Oconee Flood Protection and the Jocassee Dam Hazard

NRC Meeting with Duke Energy Carolinas
August 28, 2008

Random Dam Failure Frequency Issue

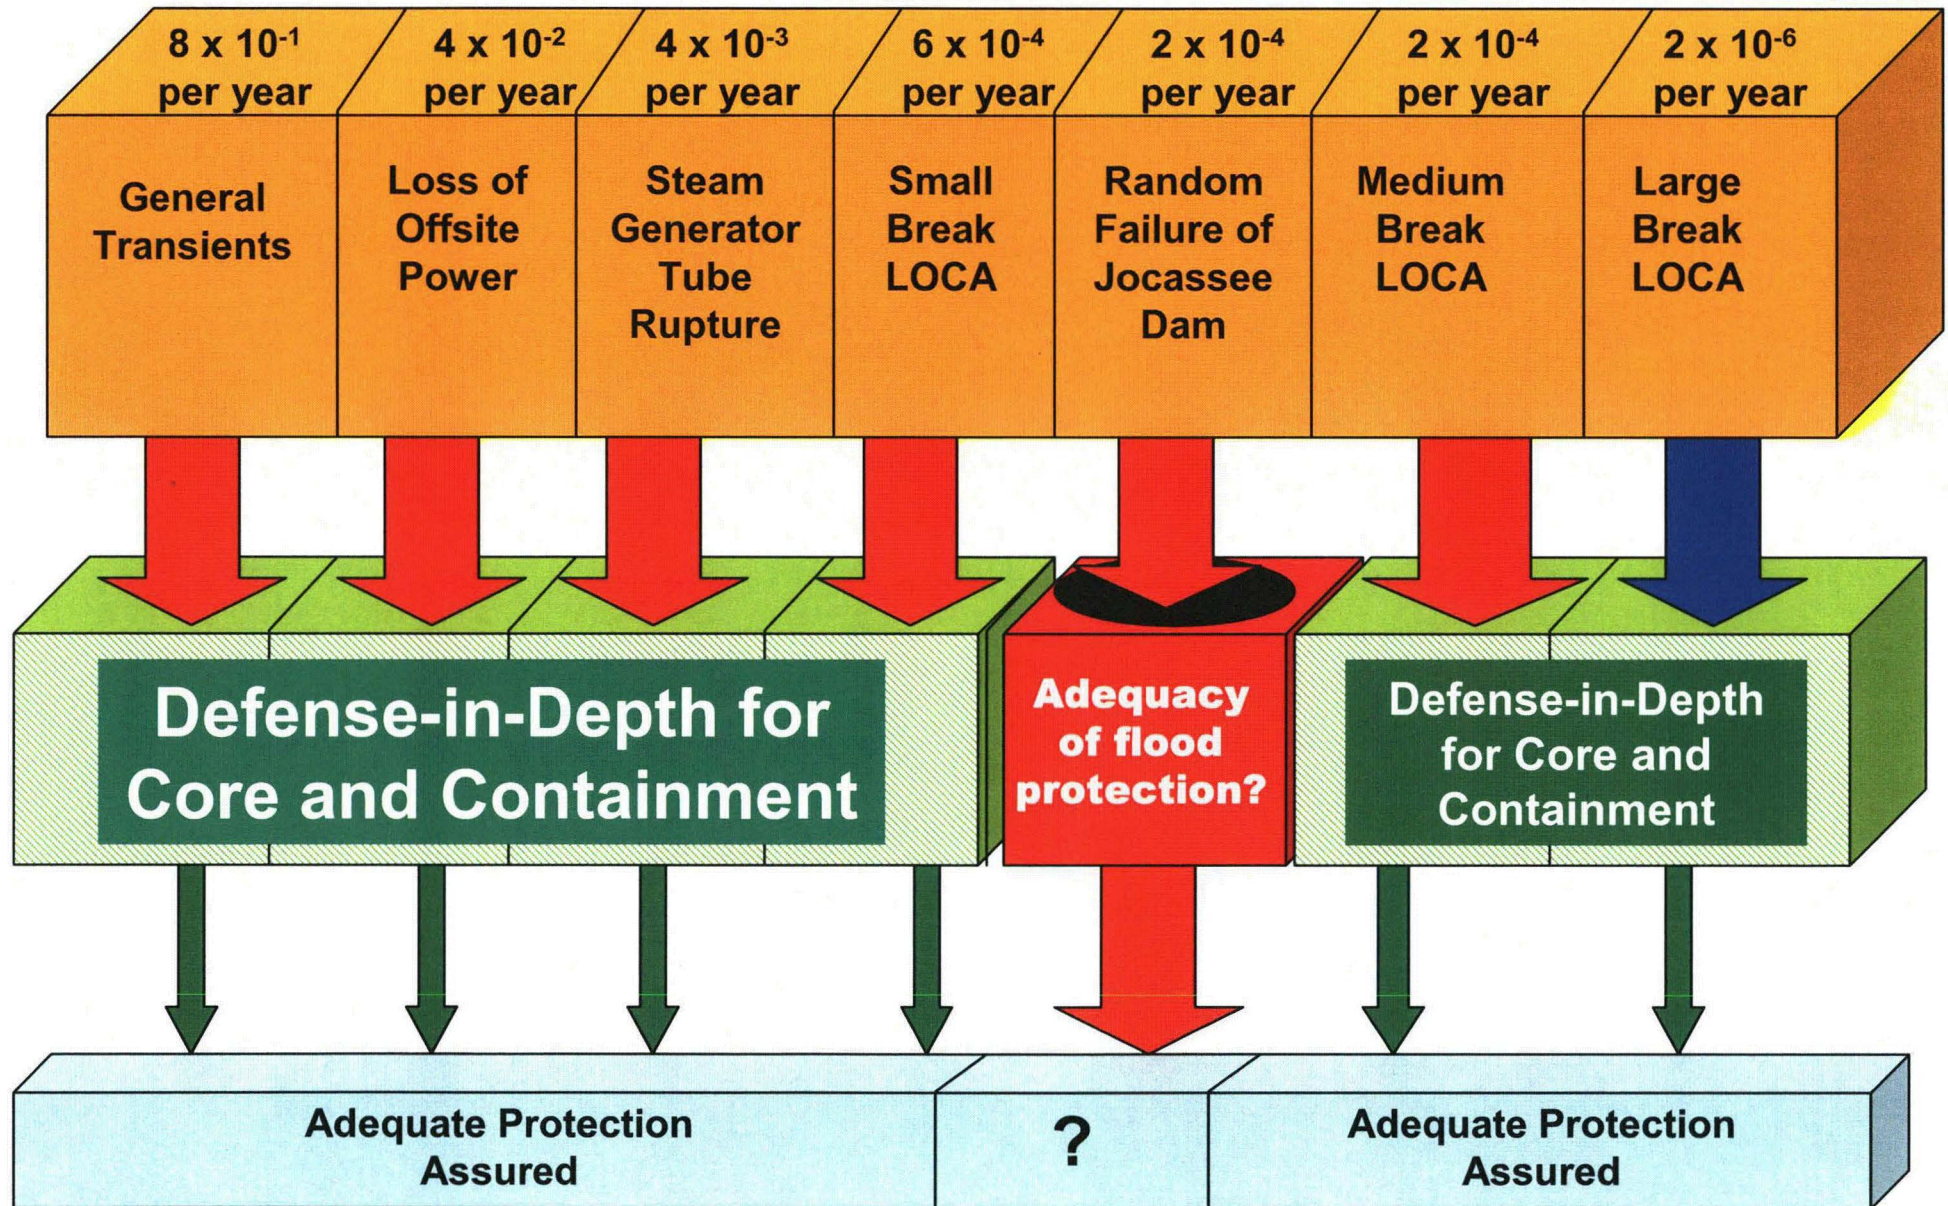
- NRC discovered an underestimate of random Jocassee Dam failure frequency as part of the Significance Determination Process (SDP).
- NRC communicated the underestimated random failure frequency to Duke in June, November, and December 2007.
